**USA
RECALL CAMPAIGN**

REF. NO. C24000080

**REPLACEMENT OF BRAKE FLUID
RESERVOIR CAP**

612
SCAGLIETTI

New Adhesive Sticker

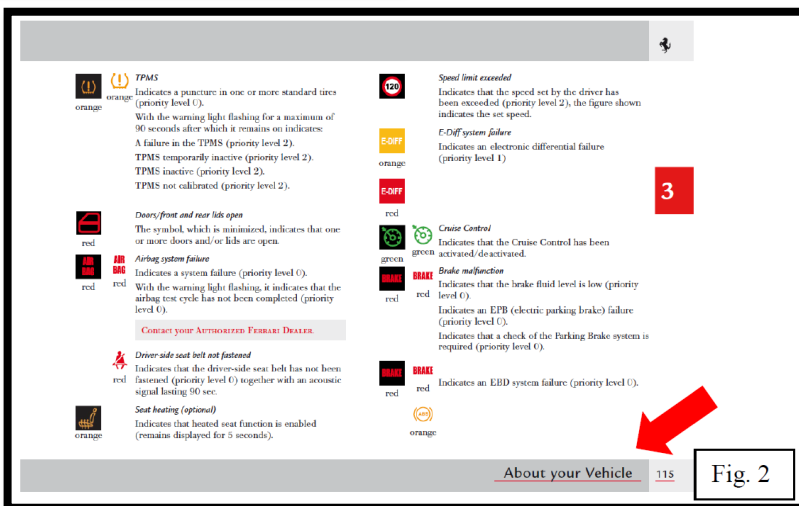
Please find below the proper location and instructions on how to insert the provided sticker into the Owner's Manual (PN: 079641778)

The sticker must be placed on the page shown above in the Owner's Manual. This page is located in the **"About Your Vehicle"** section where the warning lights on the instrument panel are described. Please be sure to attach it to the page with the **"Low Brake Fluid"** description as shown above in Fig. 2.

Once you locate the proper page, remove the adhesive protector off of the back of the sticker. Ensure there is no residue or other particles on the page that may inhibit the longevity of adhesion to the page. Place the sticker to allow the bottom of the sticker to lay directly above the gray margin at the bottom of the page that contains the text **"About your Vehicle"**.

Once applied, apply pressure across the whole strip of 'glue' to confirm the sticker has been properly mated to the page.
